REMEDY FOR NOISES TOWARDS THE ACCESSORY UNIT DRIVE

TECHNICAL INFO NO. 1108

Astra H, Signum, Vectra C, Zafira B

Z18XER

Image 1: Changing a rigid belt pulley on an over-running alternator pulley

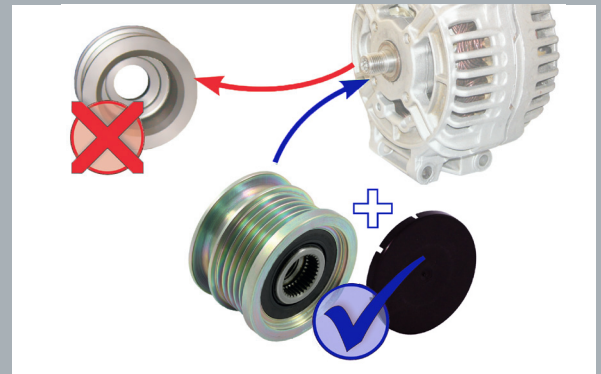
Due to the strong vibrations of the V-ribbed belt, loud noises may be produced in the vehicles listed above with a rigid alternator belt pulley.

RUVILLE recommends that the vehicles affected be retrofitted with an over-running alternator pulley 55379: **Please note:** It is essential that the enclosed installation instructions are observed!

As a technical solution, RUVILLE offers an over-running alternator pulley for these vehicles. This reduces the dynamic loads in the accessory unit drive, thus preventing noise emissions.
